Bill of Materials Backline 112/110 Preamp 206-0150-A

APPROVALS	DATE	TITLE
INT	10/10/01	BACKLINE 110/112 PRE-AMP
DESIGNED: R.A.G.	12/21/01	DRWING NO: 406-0150-A2
DRAWN: R.A.G.		PART NO: 206-0150-A2
ELEC:		COMPANY: GALLIEN-KRUEGER
MECH:		FILENAME: 6150A2 Backline 112 Preamp.sch
S/A:		
RELEASED:

L. CHANGE ALL POTS TO BRACKET STYLE.		APPROVALS		TITLE: BACKLINE 110/112 PRE-AMP	
INIT	DATE				
DESIGNED: R.A.G.	10/01/01			DRAWING NO: 406-0150-B2	REV. B2
DRAWN: R.A.G.	9/10/02			PART NO: 206-0150-B2	
ELEC:					
MECH:				COMPANY: GALLIEN-KRUEGER	
D/A:				FILENAME: 6150B2	
RELEASED:

1. CHANGE R5 TO 10.0K FROM 8.25K.		APPROVALS		TITLE: BACKLINE 110/112 PRE-AMP	
2. UPDATE ALL PAD AND HOLE SIZES.		INIT	DATE	DESIGNED: R.A.G.	10/01/01
3. CHANGE BOARD NO. TO 206-0191-A FROM 206-0150-B2.		DRAWN: R.A.G.	12/6/02	DRAWING NO: 406-0191-A	REV. A
		ELEC:		PART NO: 206-0191-A	
		MECH:		COMPANY: GALLIEN-KRUEGER	
		D/A:		FILENAME: 6191A	
		RELEASED:

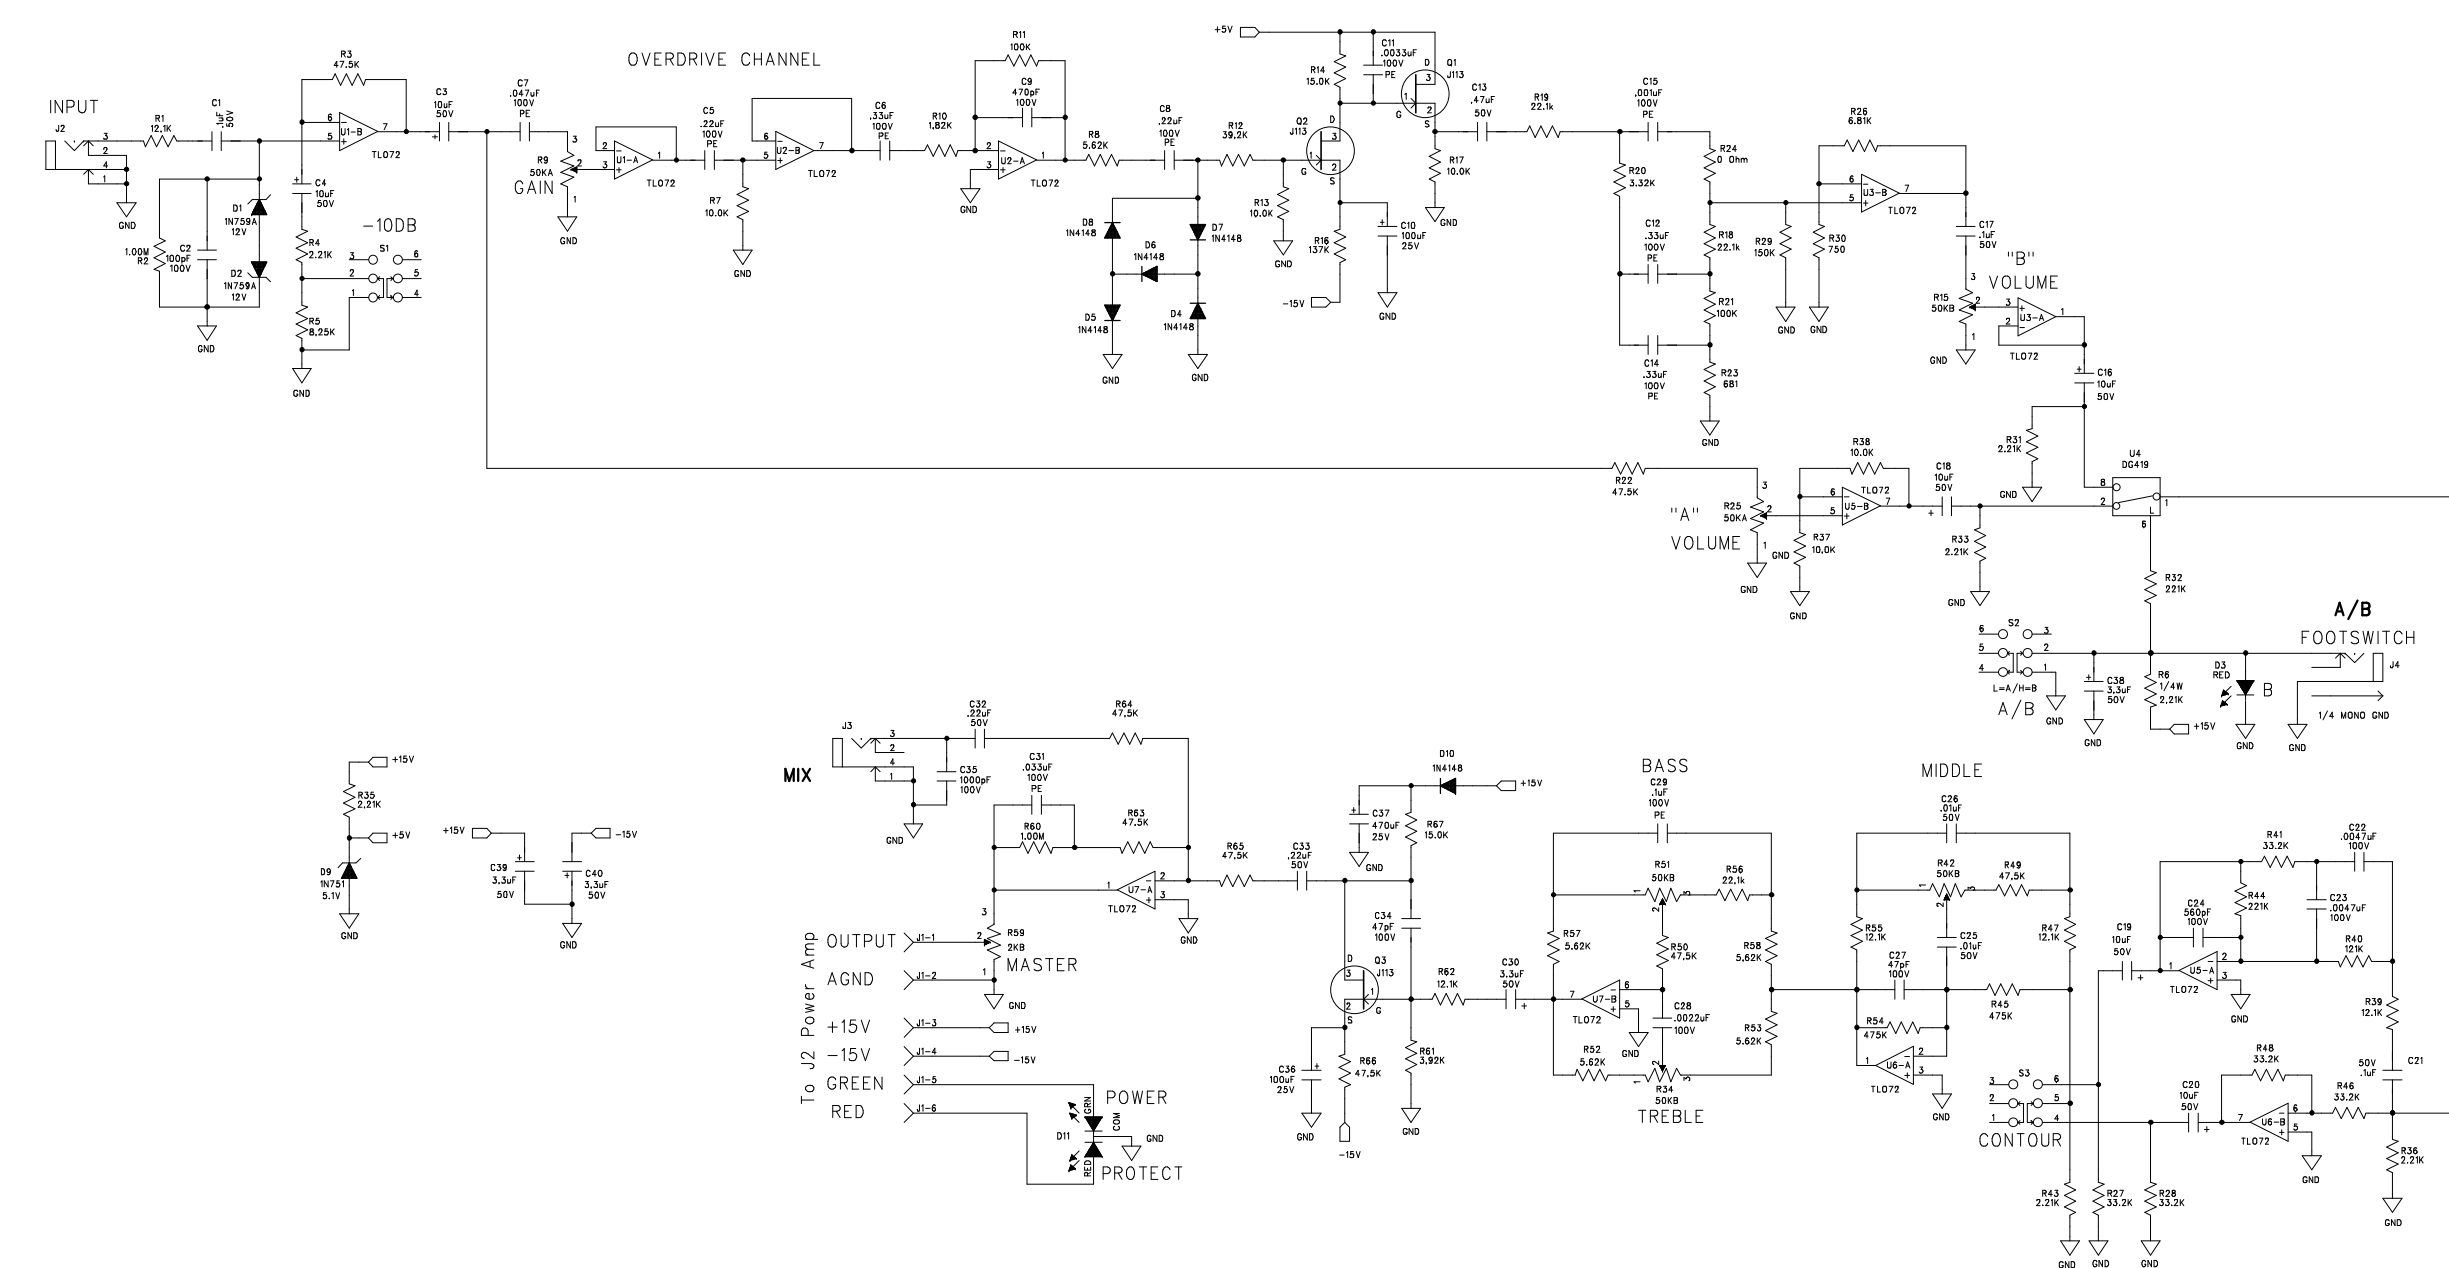
1. O1 & O2 POWERED FROM +5V. 2. OUTPUT MIXER ADDED. 3. POP CIRCUIT FOR CONTOUR 4. POP CIRCUIT FOR A/B SWITCH 5. REMOVE LED DRIVE CKT. 6. OP-AMP FOR CONTOUR OFF 7. OUTPUT BASS BOOST CKT ADDED. 8. NOTCH MODIFIED 9. TAPER OF GAIN & VOL B CHANGED.		TITLE: BACKLINE 112 PRE-AMP DRAWING NO: 406-0150-A PART NO: 206-0150-A COMPANY: GALLIEN-KRUEGER FILENAME: 6150A Backline 112 Preamp.sch
DESIGNED: R.A.G. DRAWN: R.A.G. ELEC: MECH: Q/A: RELEASED:	APPROVALS INIT DATE 10/01/01 10/8/01	REV. A B

Bill of Materials Backline Pre Amp 206-0150-A1

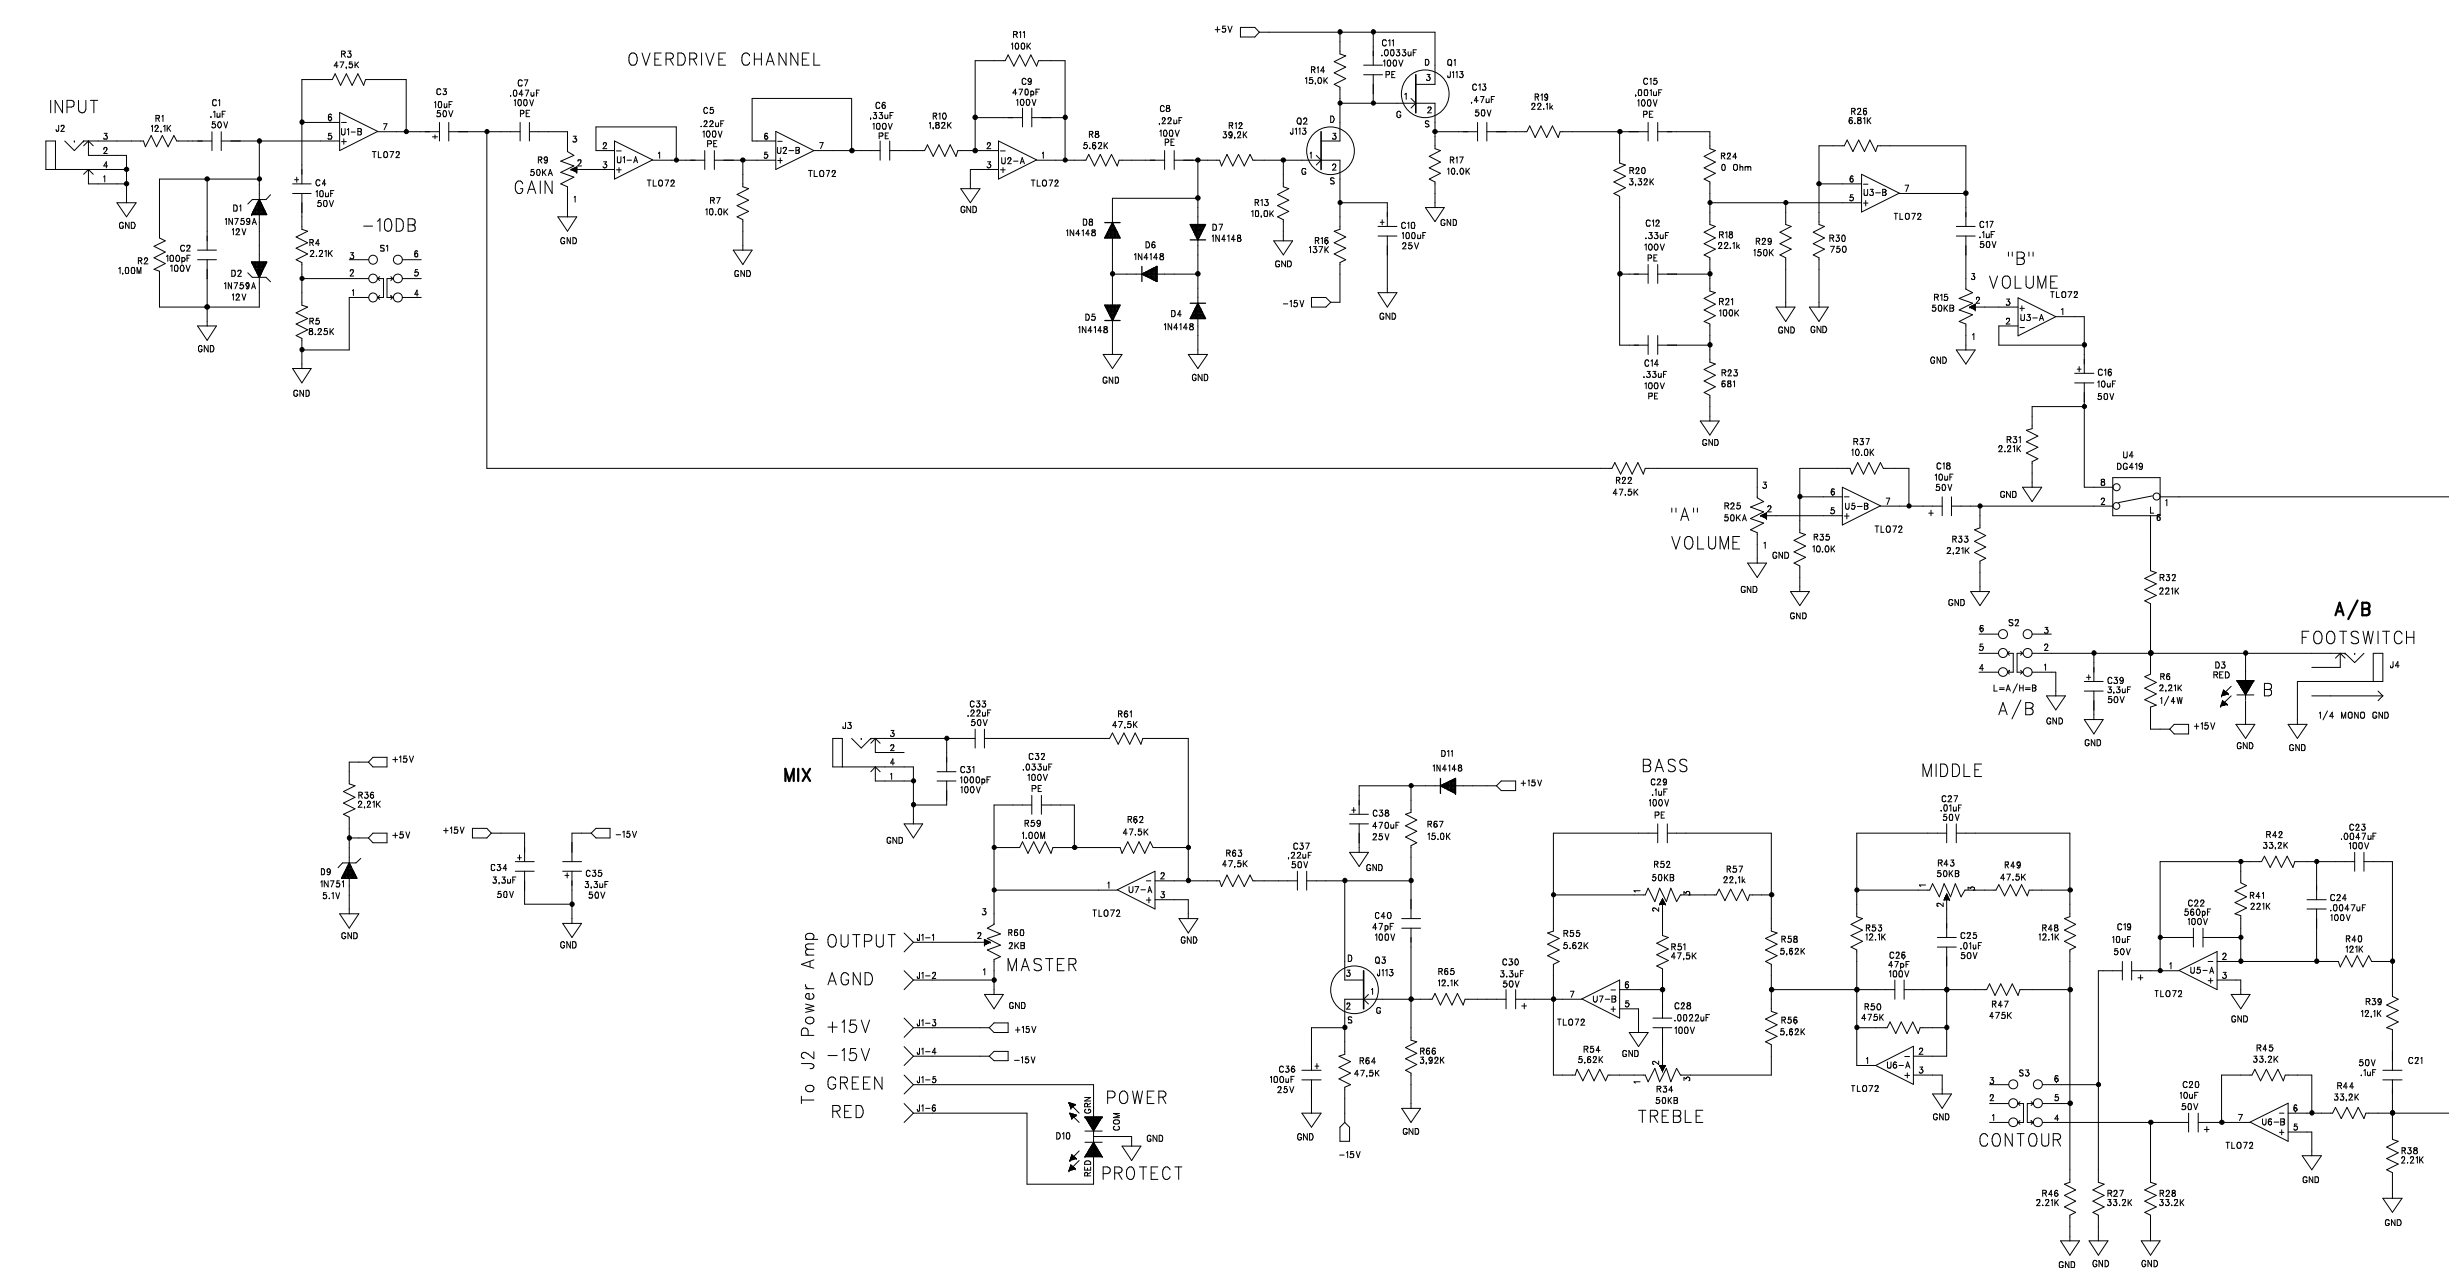
1. Moved parts and added notch for Transformer.		APPROVALS		TITLE: BACKLINE 112 PRE-AMP	
INIT	DATE				
DESIGNED: R.A.G.	10/01/01				
DRAWN: R.A.G.	11/13/01				
ELEC:					
MECH:					
Q/A:					
RELEASED:					
		COMPANY: GALLIEN-KRUEGER		REV. A1	
		FILENAME: 6150A1 Backline 112 Preamp.sch

DWG #420-0150-A1

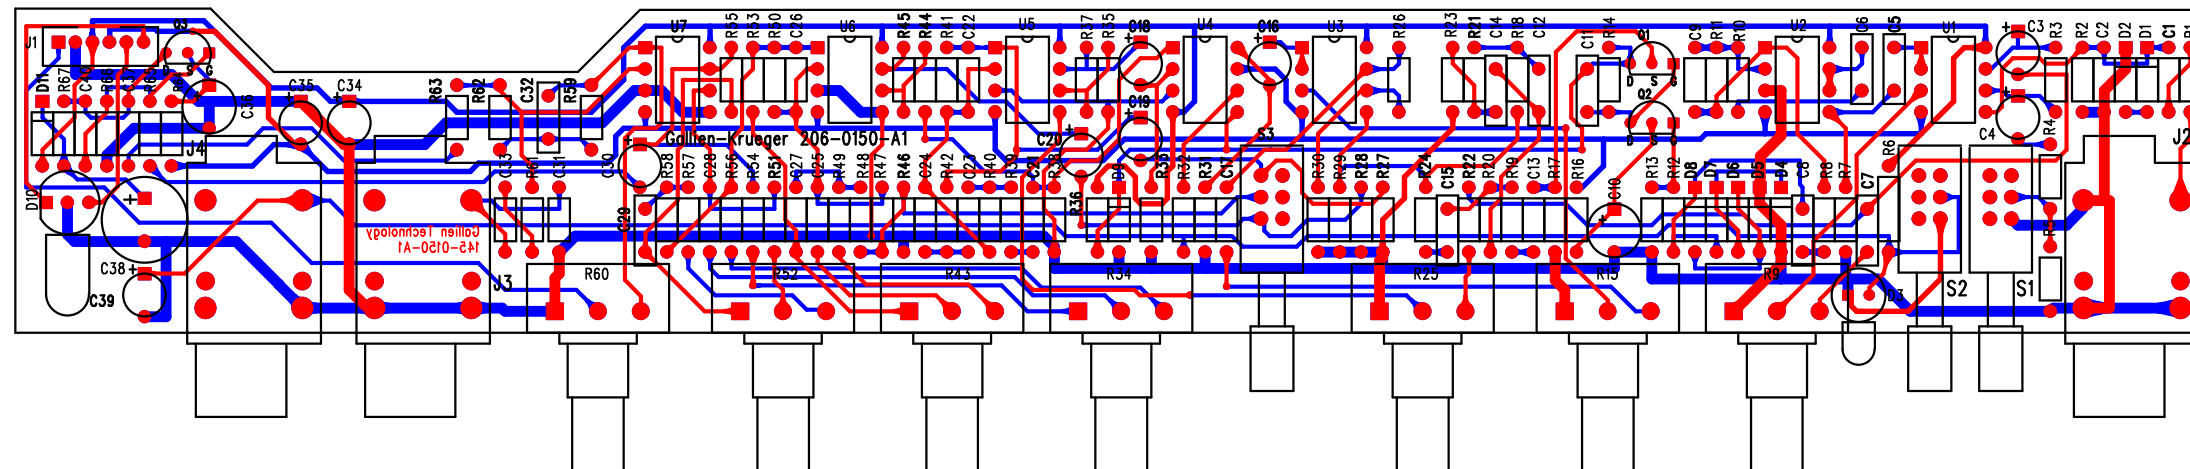
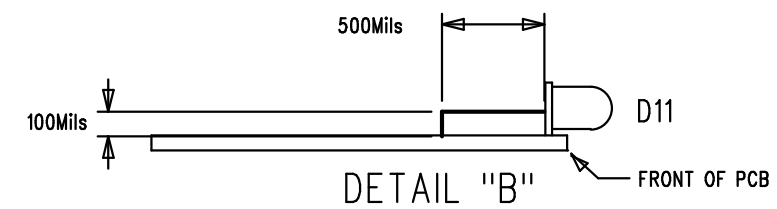
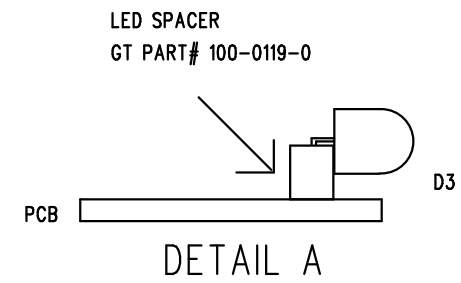
NOT VALID UNLESS STAMP IS RED	gallien technology		2240 PARAGON DRIVE SAN JOSE CA. 95131 VOICE: 408-441-8081 FAX: 408-441-8085	
	APPROVALS		TITLE: BACKLINE 112 PREAMP BD	
Put notch in board for transformer.	INIT	DATE	SIZE	DRAWING NO: 405-0150-A1
	DESIGNED: R.A.G.	10/01/01	B	REV. A1
	DRAWN: R.A.G.	11/13/01		PART NO: 145-0150-A1
LAYER DESCRIPTION:	ELEC:	MECH:	COMPANY: GALLIEN-KRUEGER	
TOP SIDE IS NOT TO BE MOUNTED	GERBER FILE NAME:		FILENAME: 5150A1 Backline 112 Preamp.pcb	
	5150A1.pcb

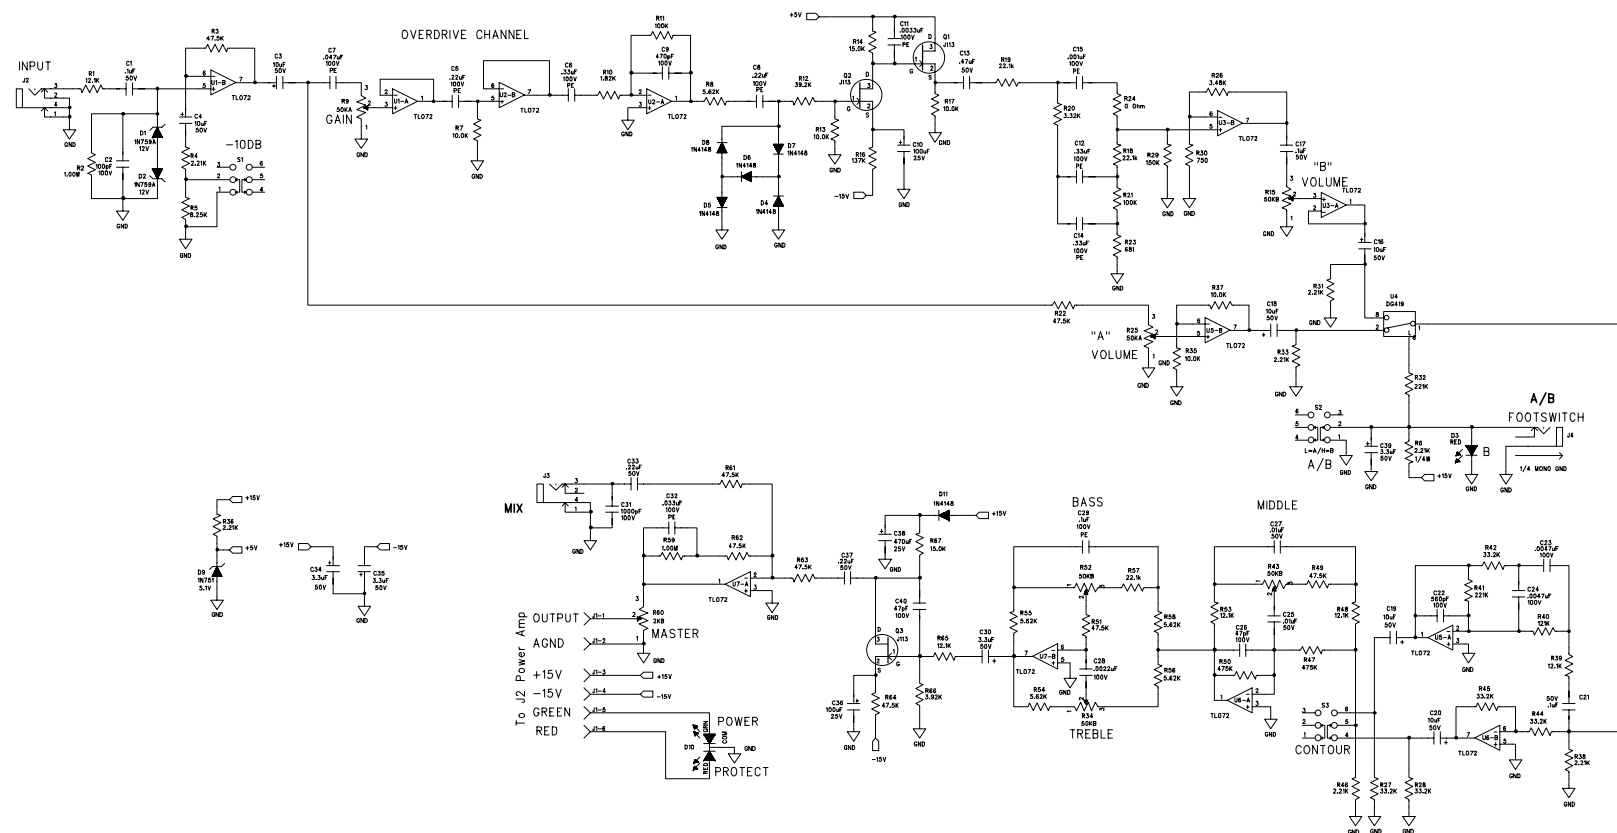
1. Reduced gain in overdrive channel

REVISION RECORD		
ECD NO:	Description Of Change	DATE:
A2	R26 to 3.48K from 6.81K	12-21-01
